Objection submission COM/2019/81 -

Proposed extractive footprint in southwest and west is prohibited
for at least eight independent reasons

Reason 4 - City Plan, Environmental Significance Overlay Code 8.2.6.3, AO1

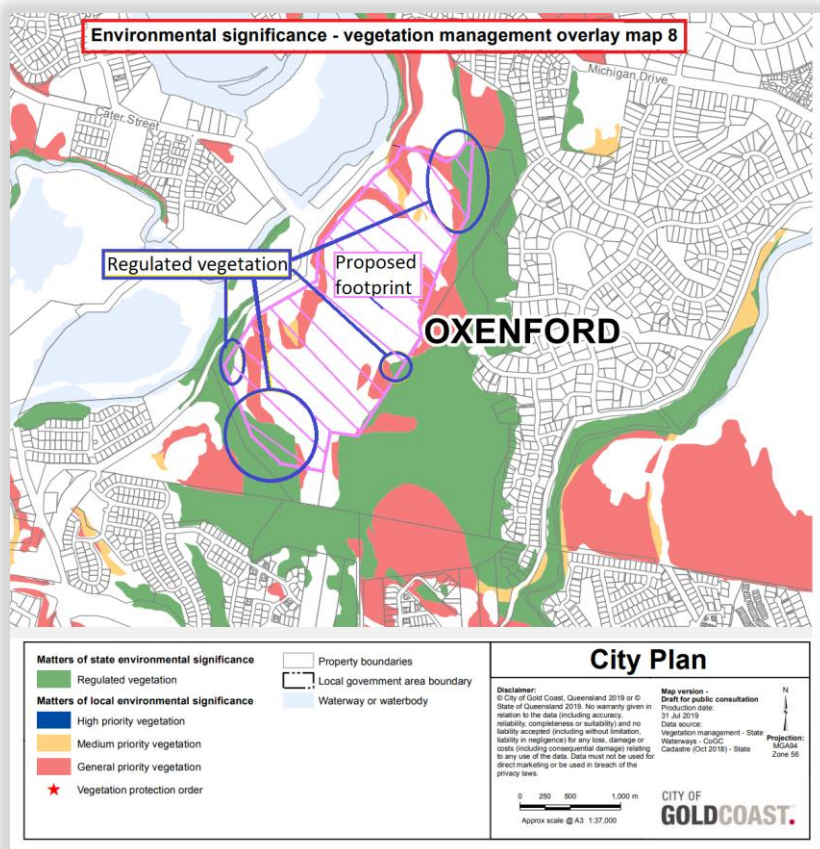
The fourth reason this is unacceptable is because the City Plan Environmental significance overlay code (8.2.6.3), Ecological site assessment, Acceptable Outcome AO1 states: *“Proposed works do not impact on: (a) areas identified on Environmental significance - vegetation management overlay map”*. However, the proposed extractive footprint engulfs protected areas:

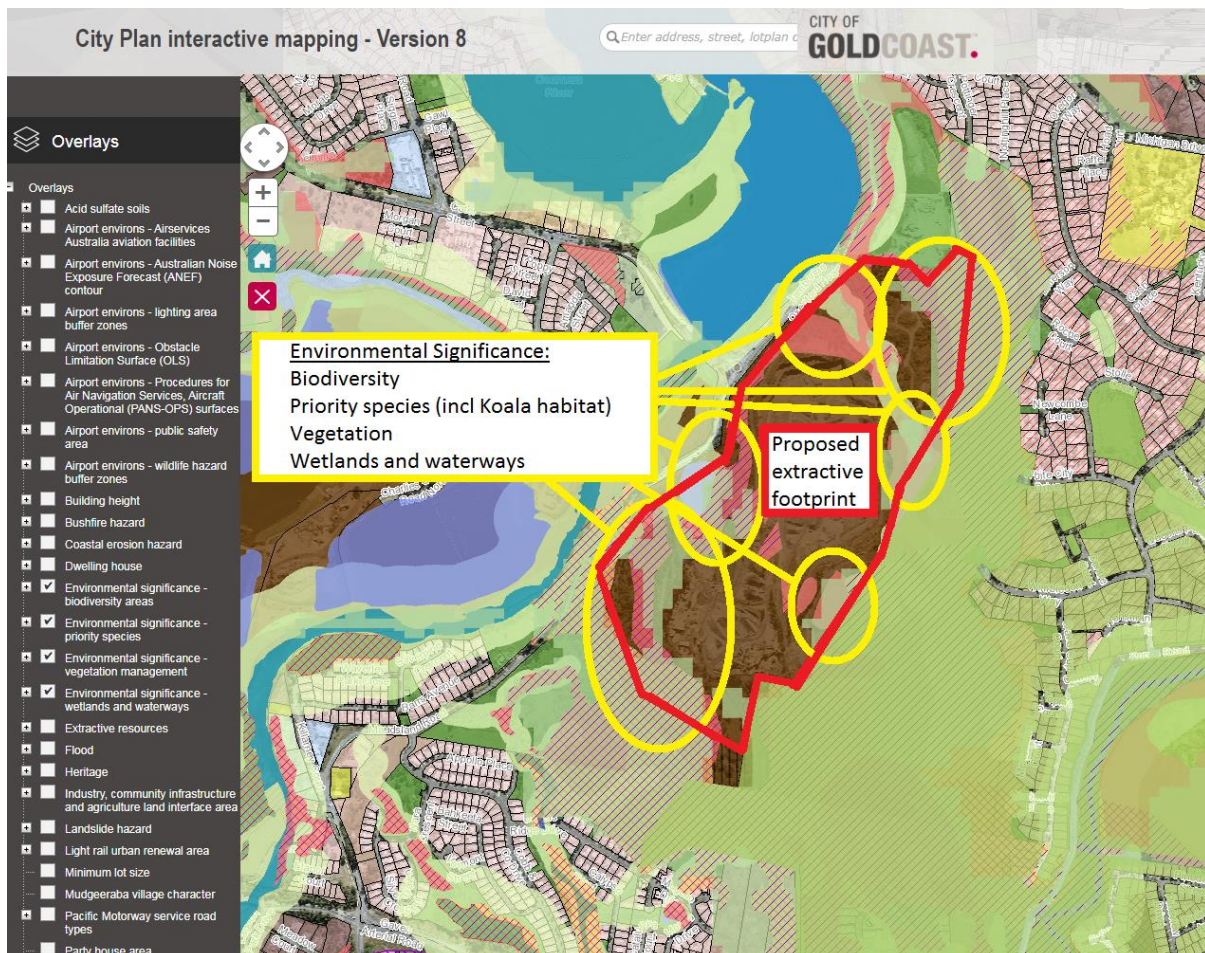
The fifth reason this is unacceptable is because the City Plan Environmental significance overlay code (8.2.6.3), Biodiversity areas, Performance Outcome PO2 states: *“Development does not impact on Protected Areas as identified on the Environmental significance - biodiversity areas overlay map”*.

This development application is clearly attempting to contravene this clear City Plan requirement as shown in the City Plan map below:

Attachment D1 - Sherman Drive, Upper Comara looking east to quarry

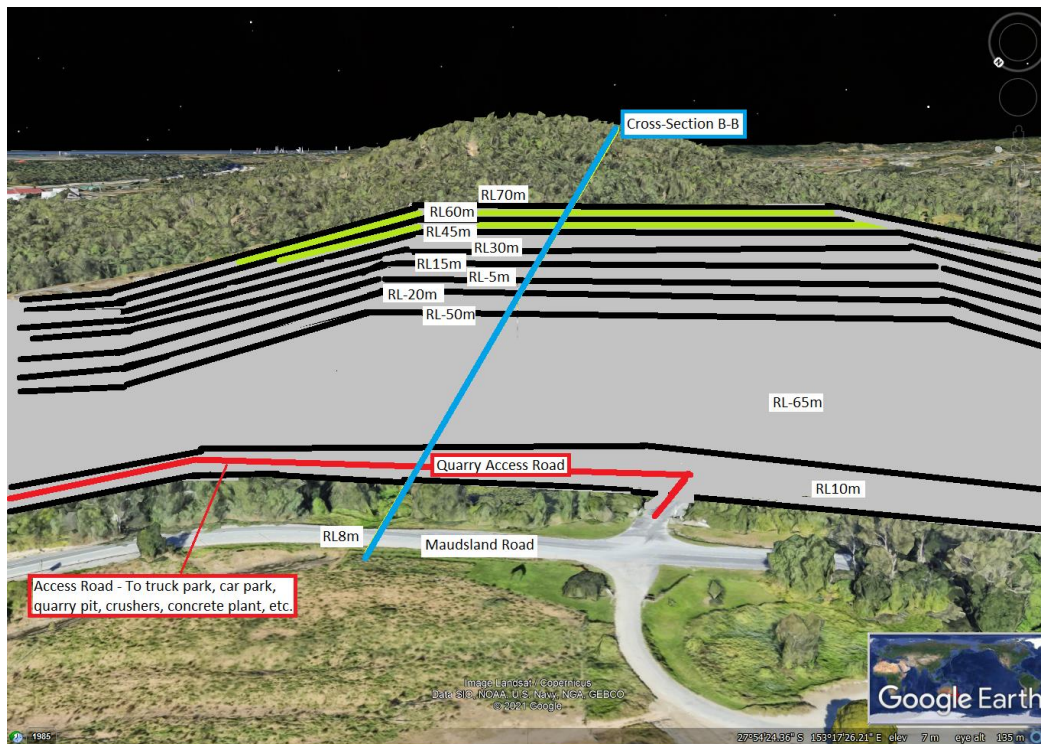
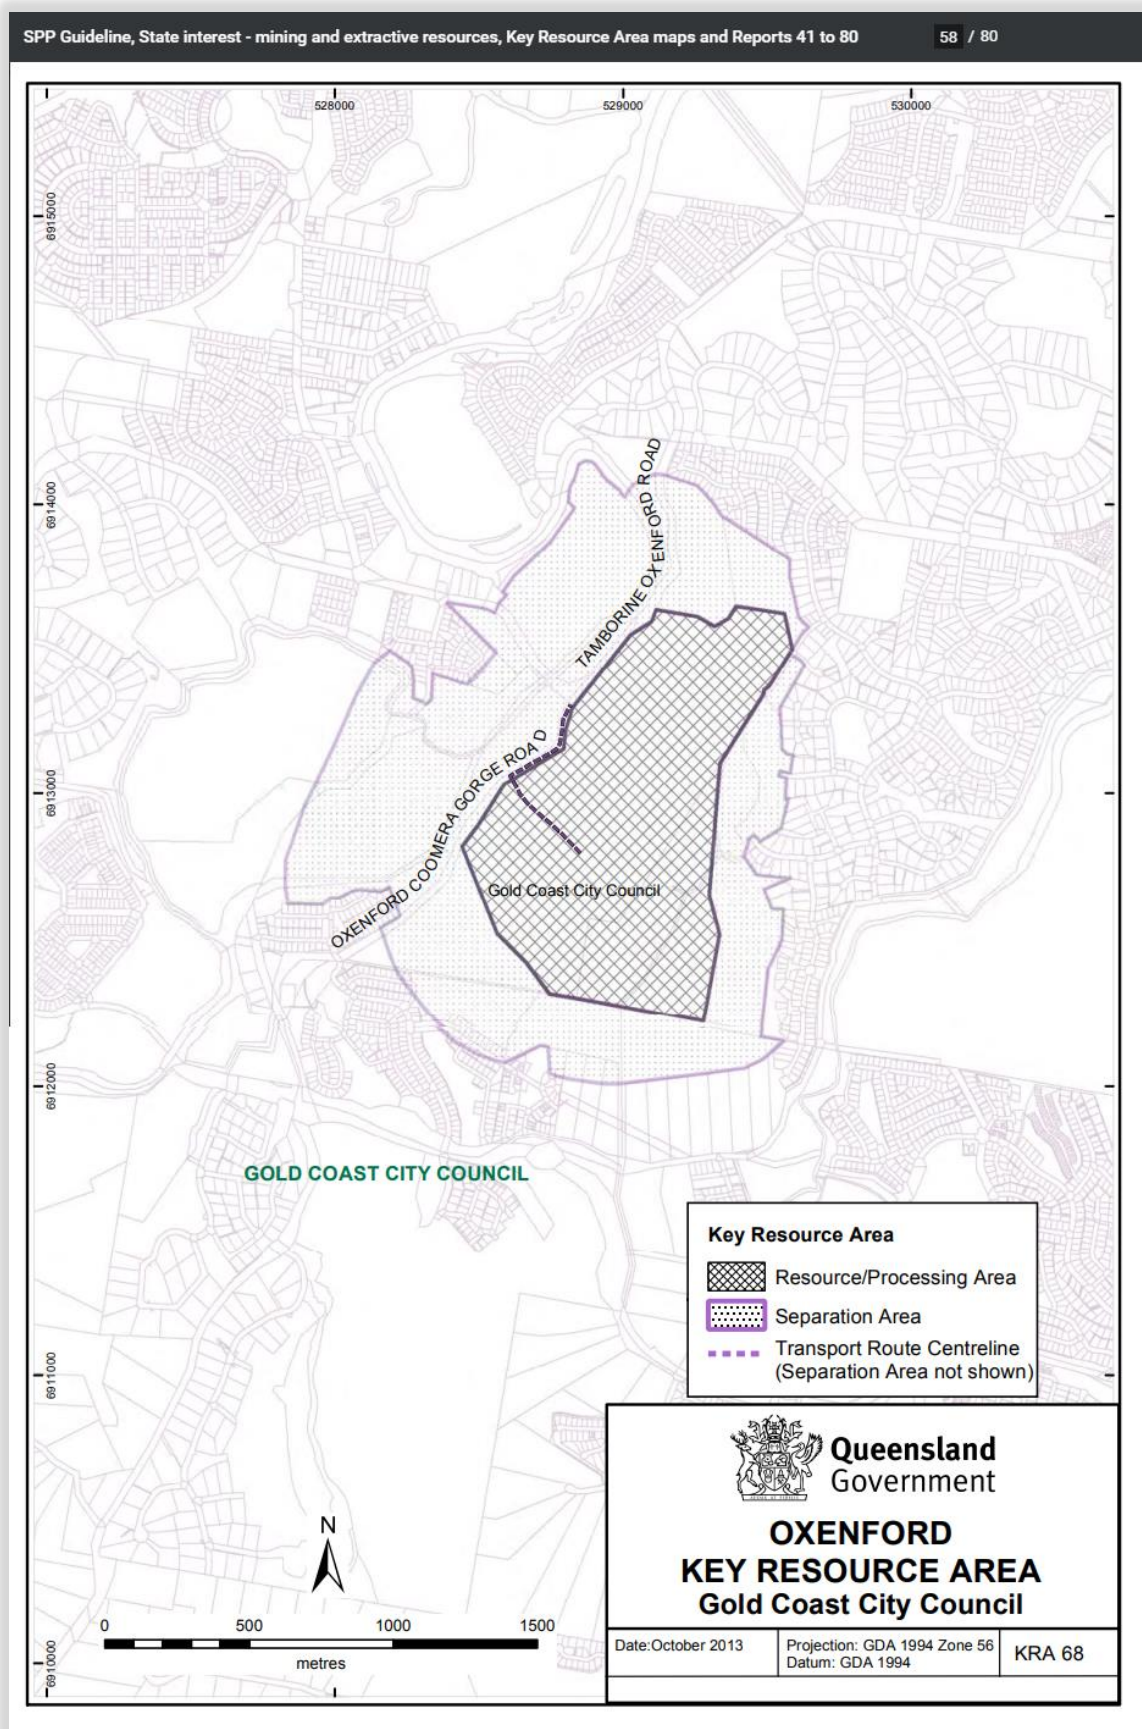
Unrestricted by any topographical features view into the quarry's inner workings

The believed extent of the affected view when the proposed expansion is progressing
